AWW Response to AONB Unit comments, dated 2nd November 2023

P/FUL/2022/06840 - Knoll House Hotel, amended application

Existing view from the south

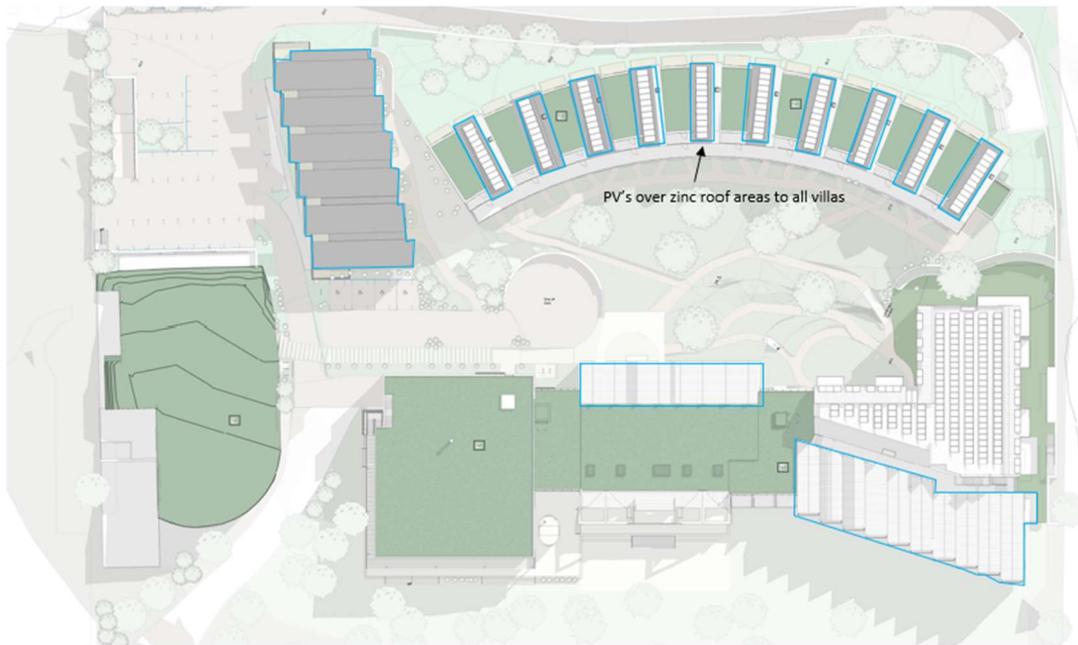
Concerning the amendment to the apartments situated at the north of the site, from 4 storeys to 3 storeys, this is noted to result in only marginal improvements to the overall impact of the redevelopment. Although the AONB Team’s advice included a recommendation to make this change, there were also numerous other amendments suggested, including the reduction in the height of the proposed 3 storey villas, which are located in the most elevated part of the site.

AWW- the 3 storeys villas are not visible from outside the site beyond the view shown on page 12 of the addendum, the update improves the massing so that from the viewpoint it is less impactful. It provides no greater impact, and we would consider is much less, than the existing built form facing this boundary: The materials selected ensure that the new buildings blend more sympathetically with the surrounding landscape and natural environment.

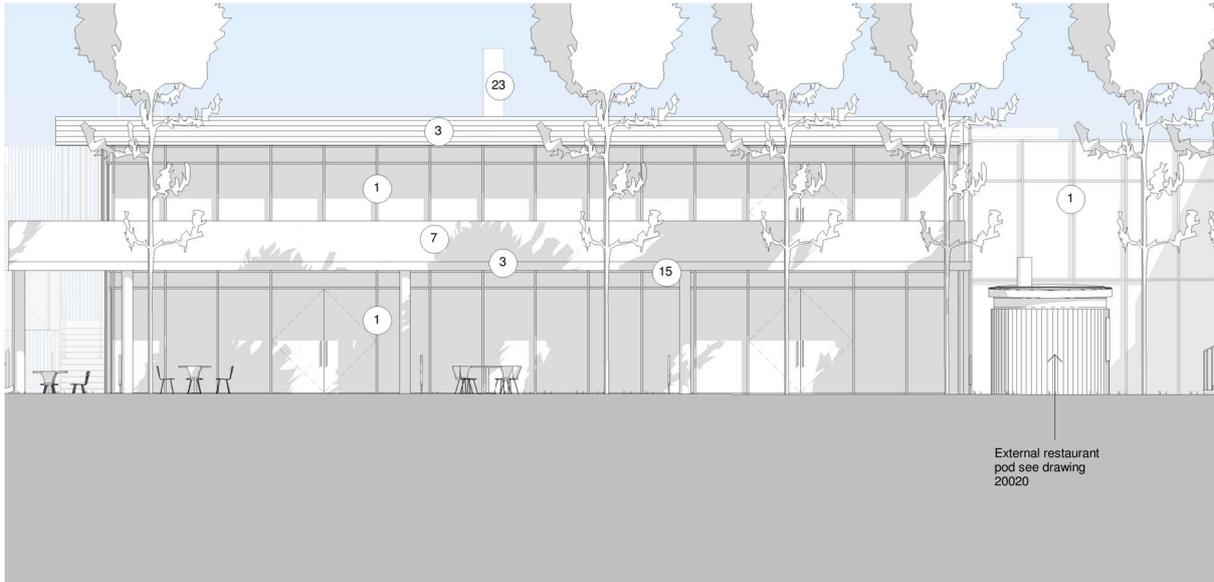
Whereas the amendments appear to be reflected in some elevational drawings and sections, the DAS addendum and wider materials containing photomontages do not appear to show the changes. From the information that is provided, some modest improvements are noted, particularly in relation to the first floor of the restaurant's aspect toward Ferry Road and the southern elevation of the spa building. However, the overall appearance is not substantively altered through these changes.

AWW - the amount of glazing to the first floor of the restaurant has reduced significantly, approximately 50% less than was previously shown, see below before and after images, the shaded areas are solid:
